Access Compliance Report

Public Rights-of-Way

(Curb Ramps)

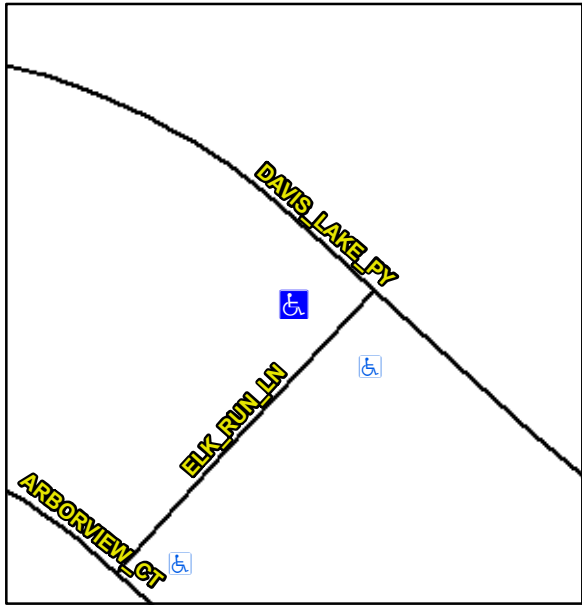
Intersection ID: 3675		Main Street: DAVIS_LAKE_PY		Cross Street: ELK_RUN_LN		Location: W																																																																																																																																																											
ADA ID: 0218DAAF2135		Ramp Type: Directional1		Initial Pass/Fail: Fail		Overall Compliance: No		Severity Score: 50																																																																																																																																																									
Codes/Mitigation Info/Possible Solution				Field Measurements/Component Compliance																																																																																																																																																													
<div></div> <div>Street 1 NameELK RUN LN</div> <div>Stop Condition-Street 1StopSign</div> <div>Street 2 NameN/A</div> <div>Stop Condition-Street 2N/A</div>				<div>Possible Solutions:</div> <div>Remove & Replace Entire Ramp.</div> <div>Surveyor Notes:</div> <div>ASP SURFACE</div> <div>PROW/ADA:</div> <div>R304.2.2, R304.5.3</div>

<table><tr><th>Compliance</th><th>Description</th><th>Data</th><th>Compliance</th><th>Description</th><th>Data</th></tr><tr><td>No</td><td>Ramp Slope (%)</td><td>20.0</td><td>N/A</td><td>Grade Break XSlope (%)</td><td>0.0</td></tr><tr><td>No</td><td>Ramp XSlope (%)</td><td>8.3</td><td></td><td></td><td></td></tr></table>
